**PLANNED UNIT DEVELOPMENT
& SUBDIVISION STAFF REPORT****Date: January 17, 2007****DEVELOPMENT NAME**

Grande Oaks at Hillcrest Subdivision

CONTEMPLATED USE

Planned Unit Development Approval to allow a gated private street single-family residential subdivision, and Subdivision approval to create 19 lots.

SITE PLAN

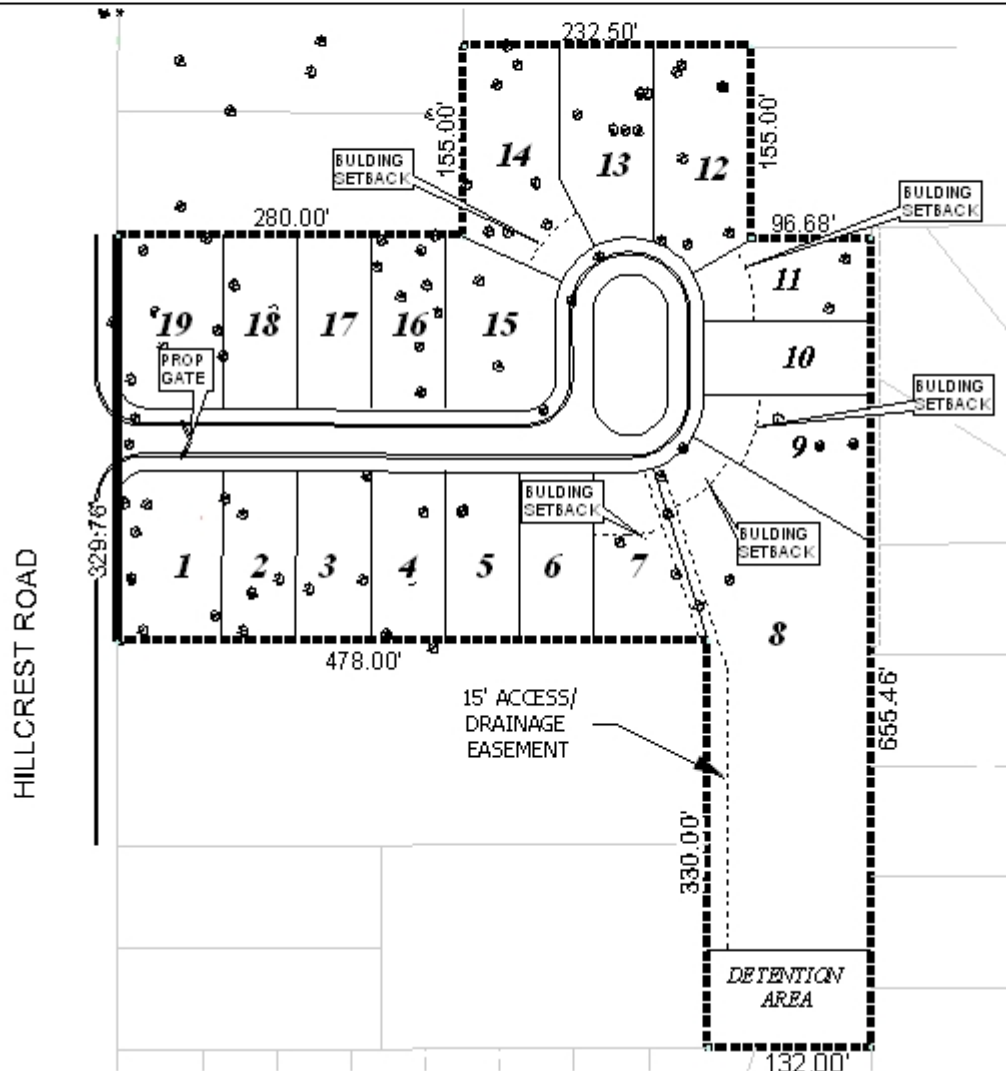
Need to show drainage easement from detention area to Weddington Court. Analysis of the receiving system will be required to determine if the existing system has the capacity to receive the additional flow. Must comply with all storm water and flood control ordinances. Any work performed in the right of way will require a right of way permit.

Preservation status is to be given to the 48" Live Oak Tree located on the Southwest corner of Lot 19, the 60" Live Oak Tree located on the South side of Lot 16, the 56" Live Oak Tree located on the South side of Lot 15, the 76" Live Oak Tree located on the Northeast corner of Lot 11, and the 54" Live Oak Tree located in the middle of Lot 4, and for all 50" and larger trees that may occur within the development, not otherwise identified. Any work on or under these trees are to be permitted and coordinated with Urban Forestry; removal to be permitted only in the case of disease or impending danger. Exact curb cut locations and location of the proposed

street and internal circulation drive should also be coordinated with Urban Forestry to ensure that no trees 50" and larger are effected.

The site fronts Hillcrest Road, a planned major street with an adequate 100-foot right-of-way. As Hillcrest Road is a major street, access management is a concern. Direct access to Hillcrest Road for any lot should be denied. Due to the limited width of each lot, each lot should be limited to one curb-cut, with the size, design and location to be coordinated with Urban Forestry, and approved by Traffic Engineering and in compliance with AASHTO standards.

Regarding the proposed gate, the current application depicts the gate a minimum of 70-feet from the edge of pavement on Hillcrest, compared with 30-feet for the previously approved plan. The additional stacking area provided by the current plan should lessen any potential problems with vehicles impeding traffic movement on Hillcrest Road.

The proposed private street will be a cul-de-sac, with what appears to be a large common area contained within the cul-de-sac. While the overall dimensions of the cul-de-sac appear to comply with the 2003 International Fire Code, as adopted by the City of Mobile, the apparent one-way circulation around the common area may not meet the minimum pavement width requirements, specifically where fire hydrants occur. The site plan and plat should be revised to ensure compliance with any requirements of the Mobile Fire-Rescue Department and Traffic Engineering.

The unlabeled area in the cul-de-sac should be labeled as common area, and a note should be placed on the site plan and plat stating that all common areas and the detention area are to be maintained by the property owners association.

All of the lots appear to meet the minimum dimensional requirements of the Subdivision Regulations, however, the minimum building setback line is not depicted for every lot. The site plan and plat should be revised to depict the minimum building setback line for each lot, where the lot is at least 60-feet in width. It should also be noted that there do not appear to be any requests by the applicant for reduced setbacks or increased site coverage, thus the standard requirements for R-1, Single-Family Residential districts will apply.

- 1) Labeling of all common areas, and placement of a note on the site plan and plat stating that maintenance of common and detention common areas is the responsibility of the property owners;

- 2) Depiction and labeling of the minimum building setback line from all street frontages for all lots, where the lot is a minimum of 60 feet in width;

- 3) Placement of a note on the site plan and plat that all lots are denied direct access to Hillcrest Road;
- 4) Placement of a note on the site plan and plat that each lot is limited to one curb-cut, with the size, design and location to be coordinated with Urban Forestry, and approved by Traffic Engineering and in compliance with AASHTO standards;

- 5) Redesign of the cul-de-sac, if necessary, after consultation with Mobile Fire-Rescue and Traffic Engineering;
- 6) Completion of the Subdivision process;
